Field Report

North Hampton Public Library

Project No: 13-020-00

Field Report No: 002

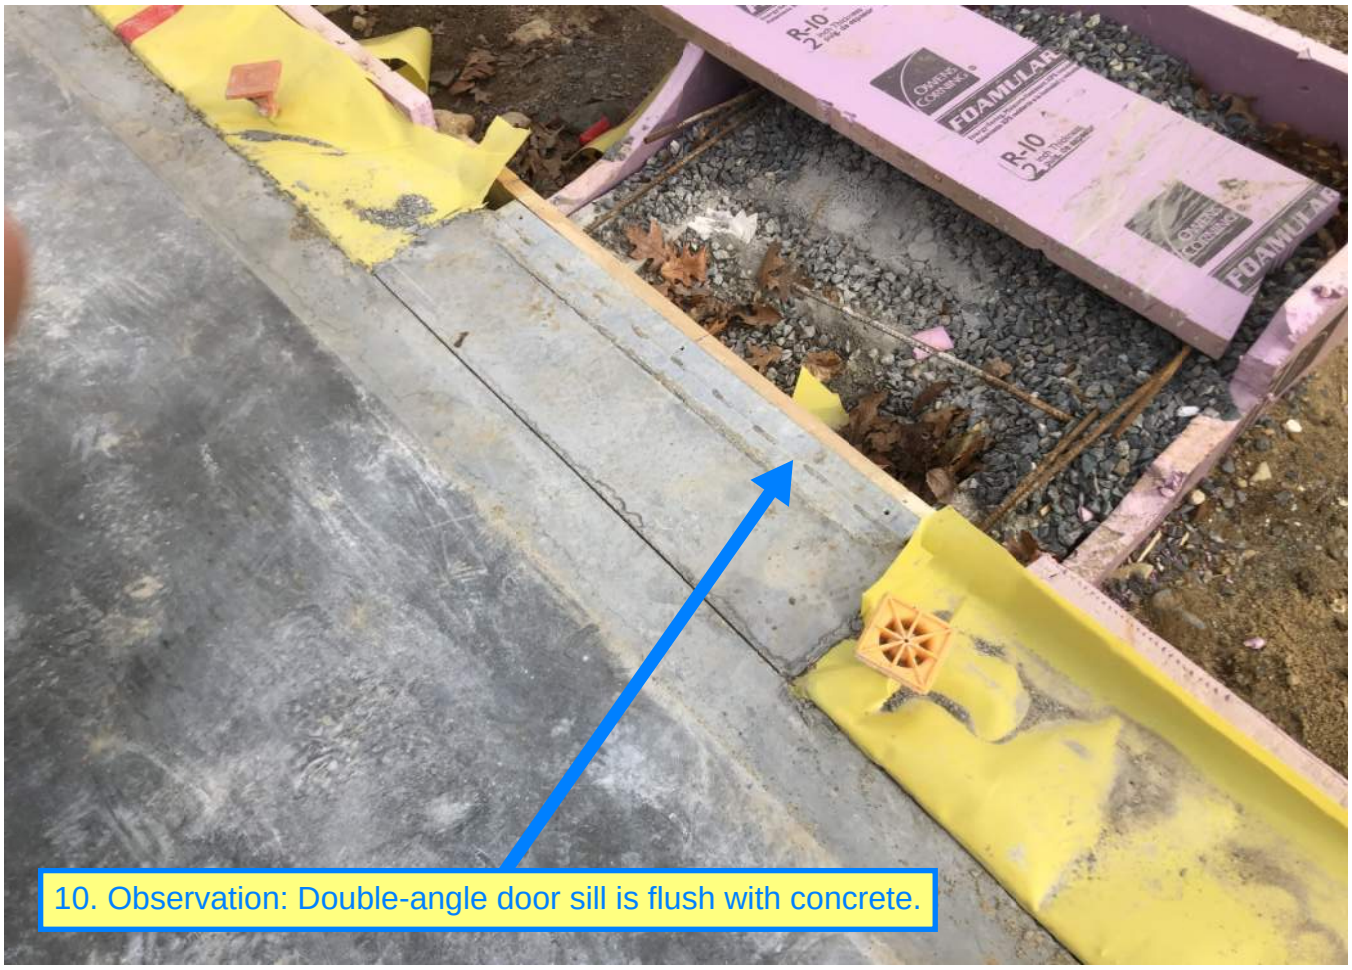
9. Observation: Slab slopes to floor drains.

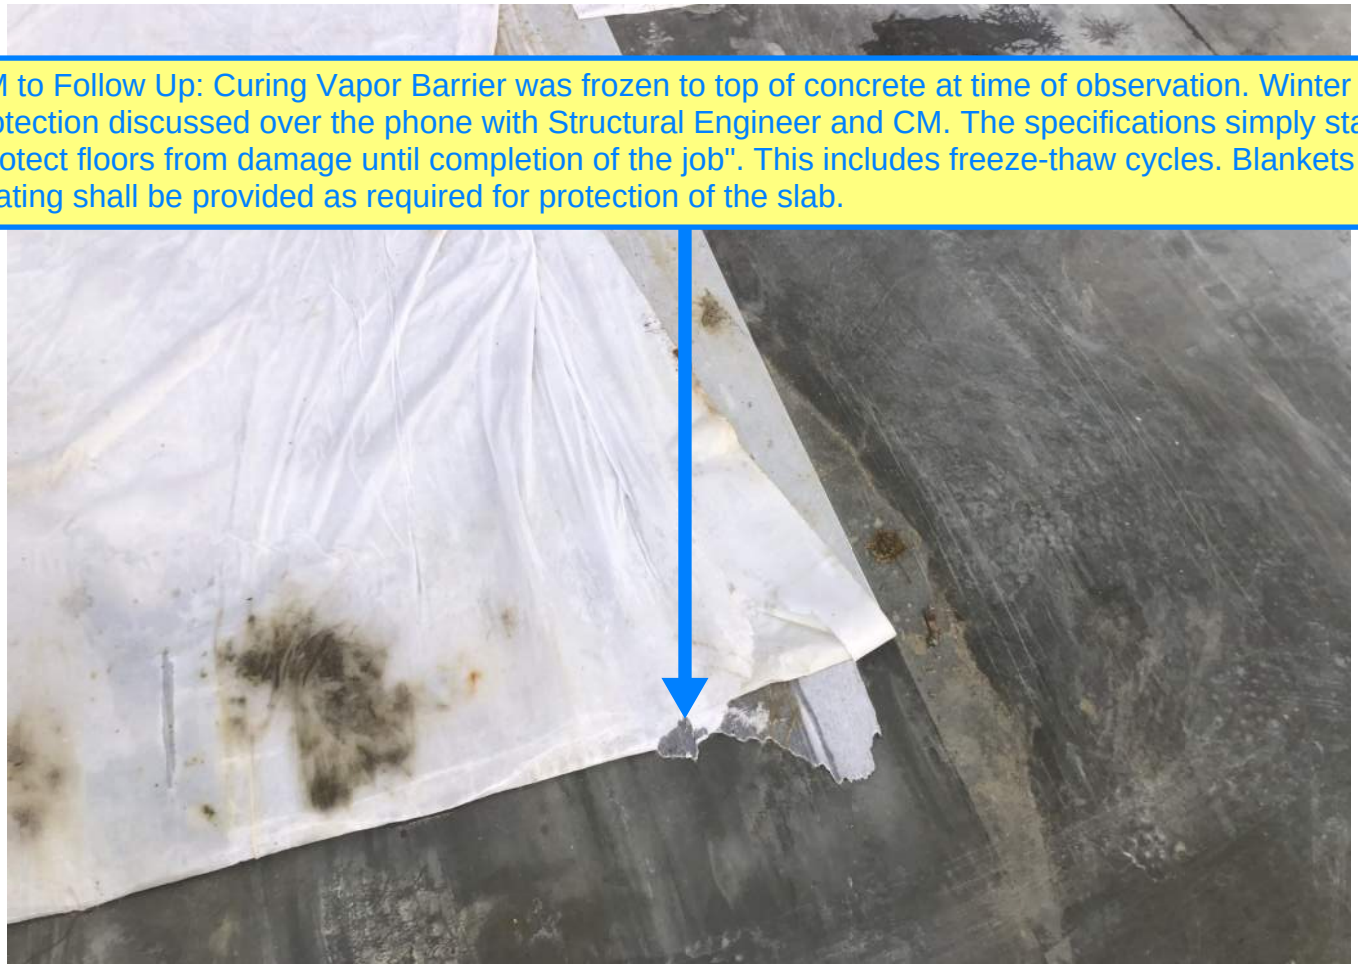
10. Observation: Double-angle door sill is flush with concrete.

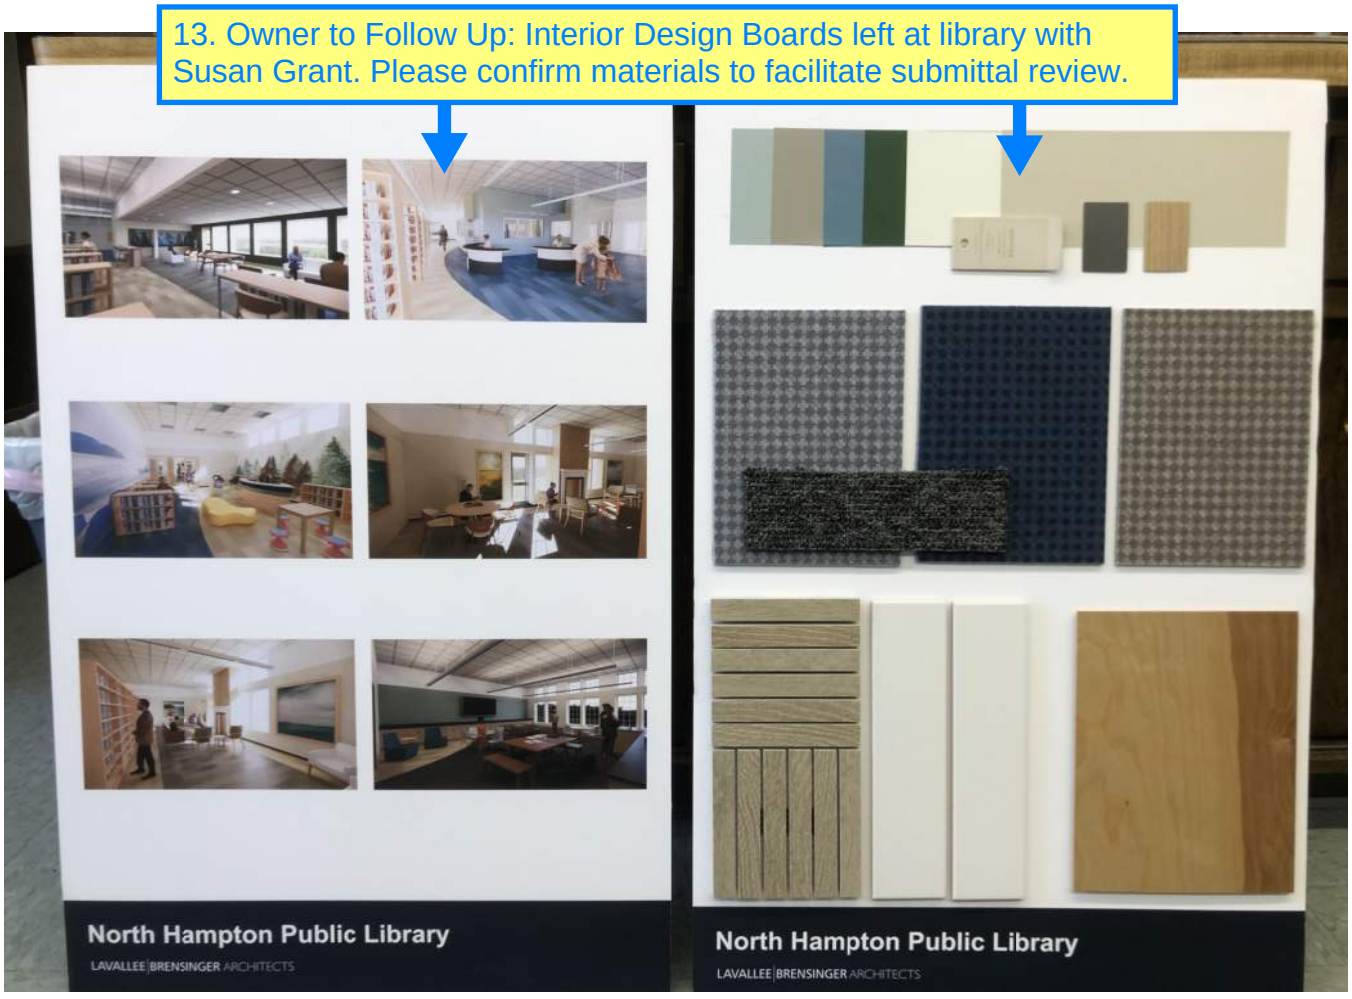
12. Observation: AOS Treatment tank has been placed, and backfill is ongoing.

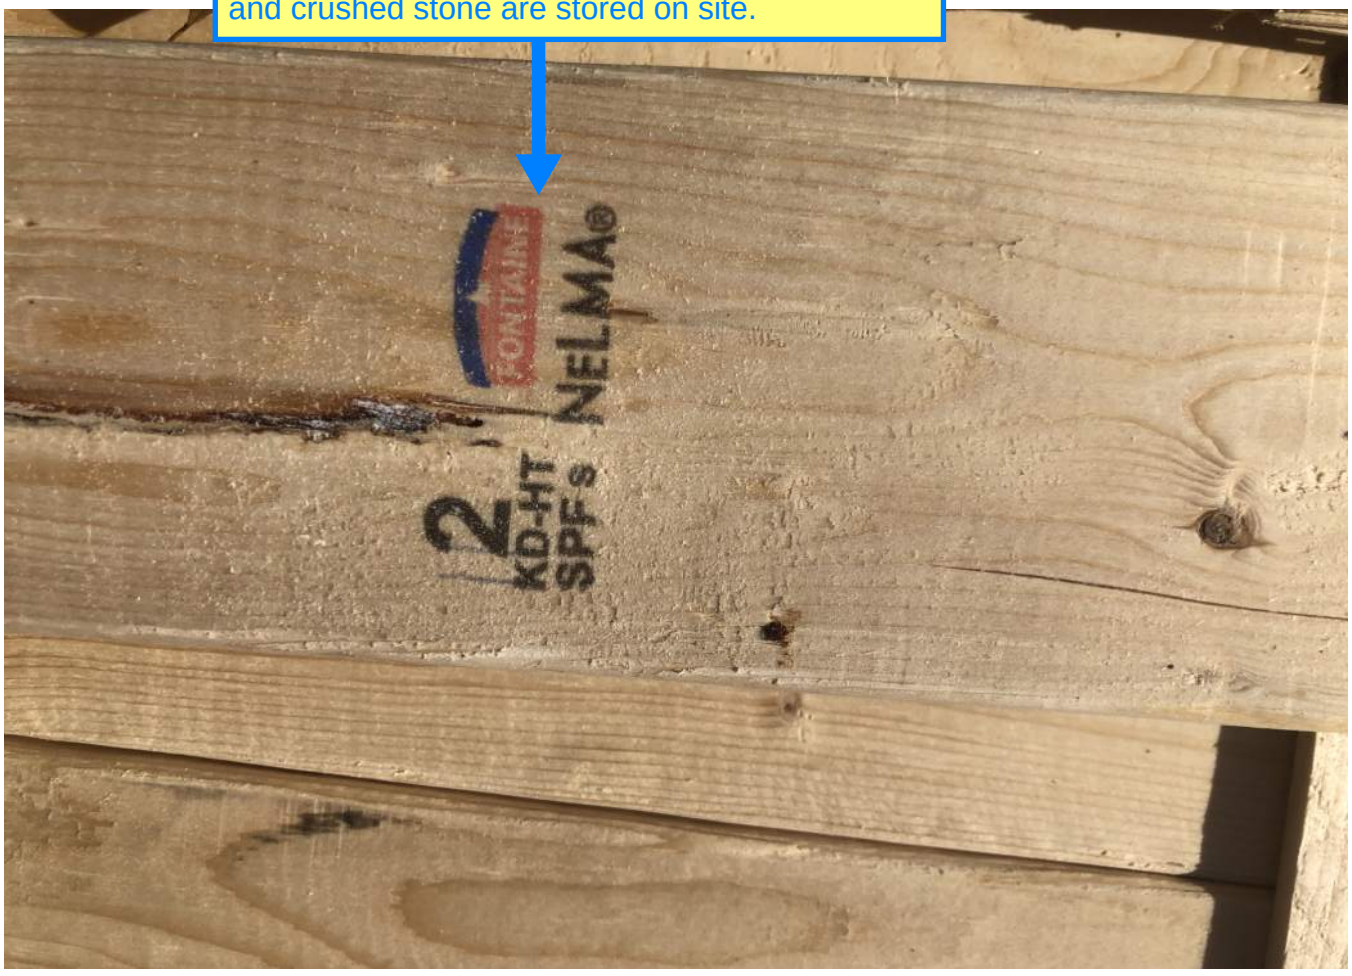
14. Observation: Lumber, Retention Structures, and crushed stone are stored on site.
